STAFF REPORT

PLANNING BOARD MEETING February 8, 2017 Amended March 2, 2017

Case #01-17: SITE PLAN APPROVAL

100 Duchaine Blvd (Map 134, Lot 5)

NOTES & LEGEND SHEET 2 OF 8

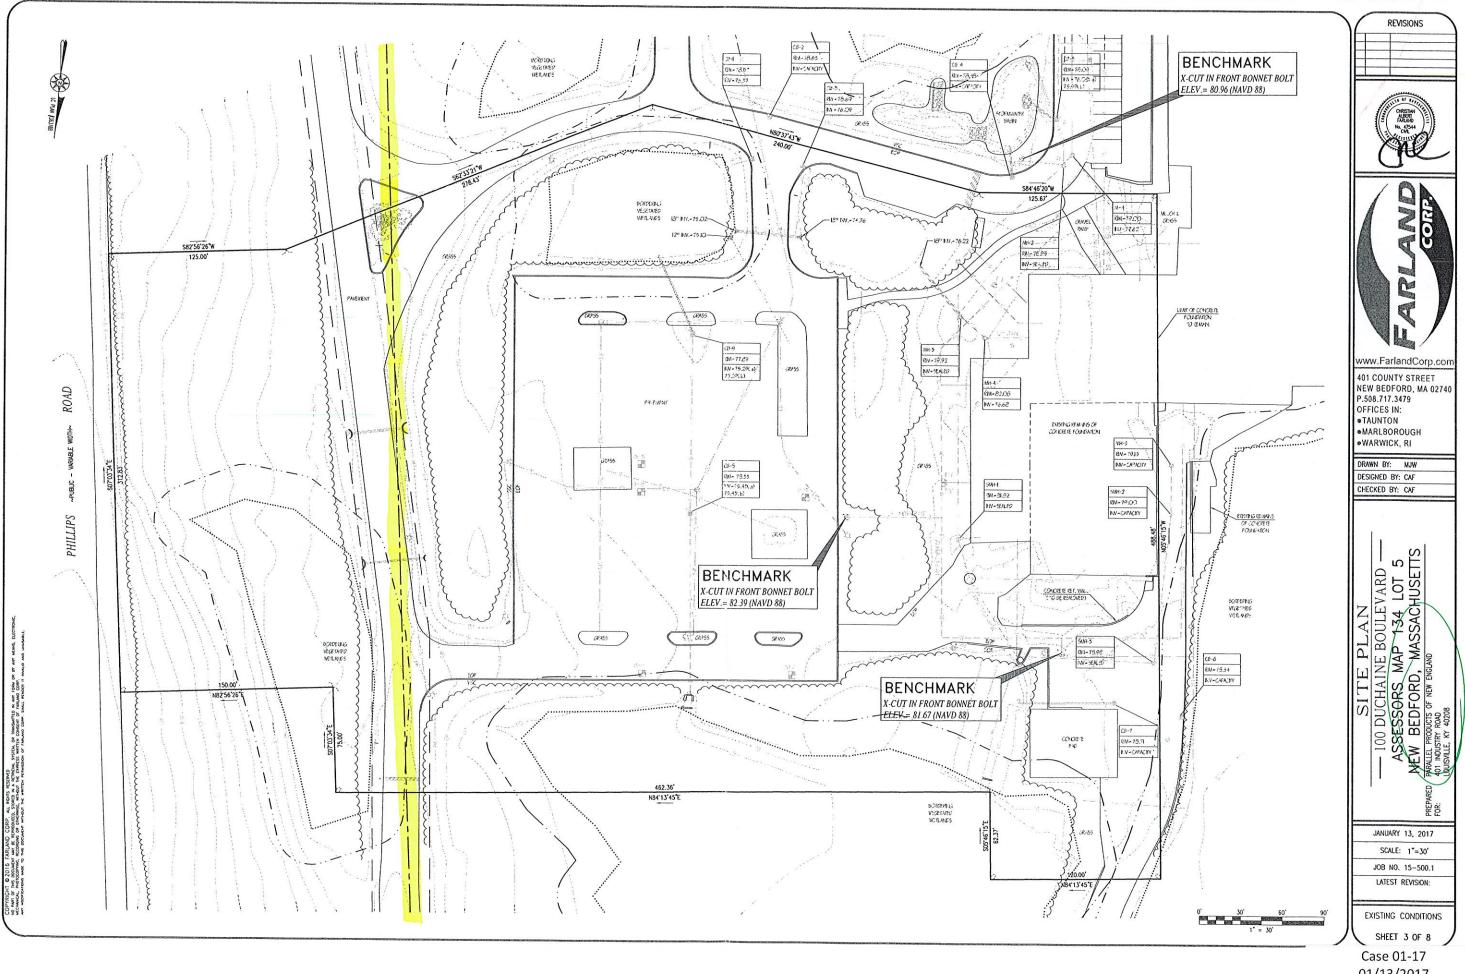
- Notes & Legend-Sheet 2 of 8
 - ☐ Change Hay bales/Hay to Straw bales/Straw.
- Existing Conditions-Sheet 3 of 8
- Layout-Sheet 4 of 8
- Utilities & Grading-Sheet 5 of 8
 - □ Please clarify the use of the term Wet Basin as used in the abbreviated storm water report. The Utilities & Grading plan notes a Water Quality Basin. Is the applicant utilizing a retention pond or are they installing detention ponds? (Please call out the storm water mitigation/attenuation design on the Site Plan for approval by the PB as well as for historical reference.)
- Detail -Sheet 7 of 8
- Detail-Sheet 8 of 8
- > Sheet 6 omitted.

Change Hay bales/Hay to Straw bales/Straw in plan Notes & Legend sheet 2 of 8.
All requirements and stipulations of the city of New Bedford Conservation Commission including the Order of Conditions are to be honored and completed as a condition of project approval.
